# Access Compliance Report

## Public Rights-of-Way

### (Curb Ramps)

| Intersection ID: 30272 | Main Street: CHALLENGER_DR | Cross Street: OLD_IRONSIDE_DR | Location:              | N                  |

| ADA ID: 03BD4B047DB0   | Ramp Type: BlendTrans1     | Initial Pass/Fail: Fail       | Overall Compliance: No | Severity Score: 25 |

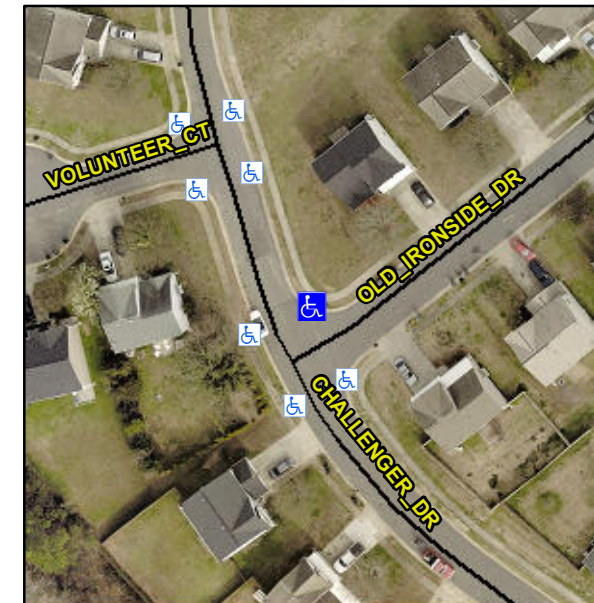
**Not Found, R304.5.3**

| Compliance | Description           | Data  | Compliance | Description                 | Data  |
|------------|-----------------------|-------|------------|-----------------------------|-------|
| Yes        | Ramp Width (in)       | 52.0  | No         | BlendTrans XSlope (%)       | 7.5   |
|            |                       |       | No         | Curb Slope (%)              | 15.0  |

**Remove & Replace Curb Ramp With Two New Directional Ramps or Equivalent.**
